STATE OF WASHINGTON
DEPARTMENT OF ECOLOGY

**Re: Opinion Pursuant to WAC 173-340-515(5) on Remedial Action for the Following
Hazardous Waste Site:**

- **Site Name:** Jackpot Station 352
- **Site Address:** 4200 Wheaton Way, Bremerton, Washington 98310
- **Facility/Site No.:** 86856327
- **Cleanup Site No.:** 10880
- **VCP Project No.:** NW2340

FIGURE 2
SITE PLAN SHOWING SOIL BORING
AND WELL LOCATIONS

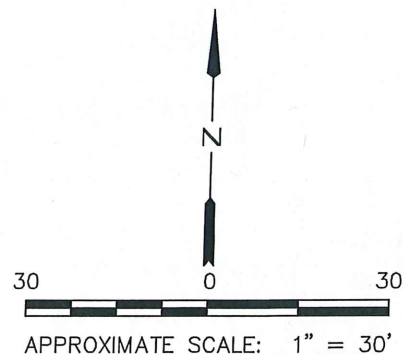
- The results identified a larger extent of contamination at concentrations above MTCA Method A cleanup levels for TPH-G and BTEX. As a result, an SVE system was designed and vapor extraction wells VE-1 through VE-4 (**See Enclosure A, Figure 2**) were installed to remediate the remaining soil contamination. In 2018, three additional SVE remediation wells (RW-1 through RW-3) were installed as soil sample analytical results indicated that petroleum impacts exceeding MTCA Method A cleanup levels continued to be present at the Site.
